**ZONING AMENDMENT,
PLANNED UNIT DEVELOPMENT &
SUBDIVISION STAFF REPORT****Date: September 18, 2008**

<u>NAME</u>	Ashland Park LLC
<u>SUBDIVISION NAME</u>	Frazier Park Subdivision
<u>LOCATION</u>	2165 Old Shell Road (South side of Old Shell Road at the South terminus of Frazier Court)
<u>CITY COUNCIL DISTRICT</u>	District 1
<u>PRESENT ZONING</u>	R-1, Single-Family Residential
<u>PROPOSED ZONING</u>	R-3, Multi-Family Residential
<u>REASON FOR REZONING</u>	None provided.
<u>AREA OF PROPERTY</u>	1 Lots / 0.5 ± Acres
<u>CONTEMPLATED USE</u>	<p>Subdivision approval to create 1 lot, Planned Unit Development Approval to allow reduced side yard setbacks for a three unit residential condominium complex and Rezoning from R-1, Single-Family Residential to R-3, Multi-Family Residential, to allow the construction of three residential town home condominiums.</p> <p>It should be noted, however, that any use permitted in the proposed district would be allowed at this location if the zoning is changed. Furthermore, the Planning Commission may consider zoning classifications other than that sought by the applicant for this property.</p>

SITE PLAN

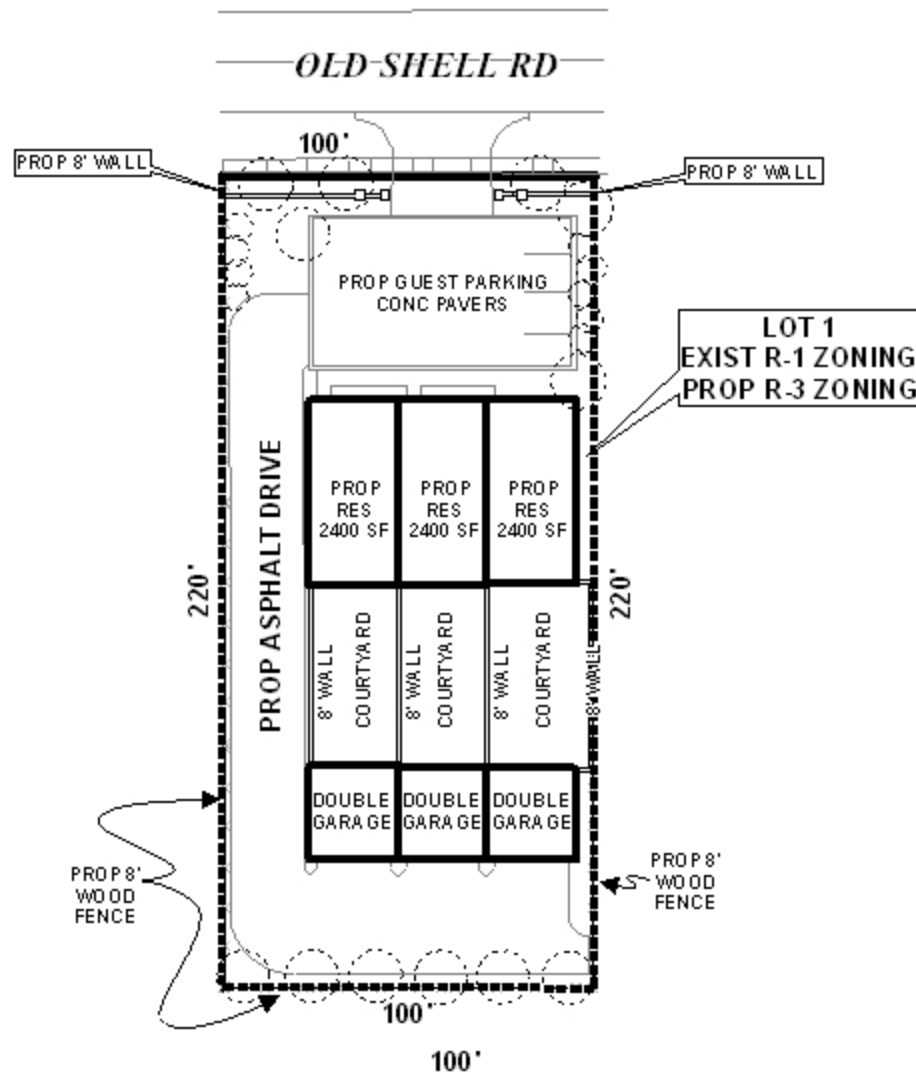
The site plan indicates that the proposed dwelling units will be 5-feet from the East property line where it abuts the B-2 district: the normal minimum side yard setback is 8 feet. An 8-foot high masonry wall is proposed along Old Shell Road, within the 25-foot minimum building setback line: 3-feet is the normal maximum height for any solid fence within the front setback area. All other setbacks appear to meet minimum requirements.

The applicant proposes 4 “guest” parking spaces between the town homes and the street, and 6 parking spaces in 3 two-car garages. A total of 5 spaces are required for 3 dwelling units. A 20-foot wide driveway will lead from the front parking area to the private garages at the rear of the property. The Zoning Ordinance normally requires a 24-foot wide driveway for two-way traffic, thus the drive will be below the width requirement. A 20-foot wide driveway may be acceptable due to the fact that it only serves 6 parking spaces and because no parking or maneuvering to serve parking would be required in the driveway area. However, fire apparatus access onto the site would not be possible due to the limited maneuvering area.

Residential PUDs also require the provision of 700 square feet of open space per dwelling unit (2100 square feet required). The landscape information depicted on the site plan shows that over 2,600 square feet of landscape area will be provided, not including the private courtyards.

The site plan also depicts trees. It appears that the site plan is one understory tree short of full compliance with the requirements of Section 64-4.E. of the Zoning Ordinance.

Storm water detention is not depicted on the site plan, but compliance with the City's storm water and flood control regulations will be required.

A dumpster is not depicted on the site plan, however, if one will be used, it must be depicted, or a note must be placed on the site plan stating how garbage will be handled.

The site will be bounded by fencing along the West, South and East property line, up to 8 feet in height. An 8-foot high masonry wall is proposed along the Old Shell Road frontage, and around the proposed private courtyards.

- 1) Placement of a note on the final plat stating that the site is limited to one curb-cut, with the size, design and location to be approved by Traffic Engineering and conform to AASHTO standards; and
- 2) Placement of a note on the plat / site plan stating that the site must be developed in compliance with all local, state and Federal regulations regarding endangered, threatened or otherwise protected species.
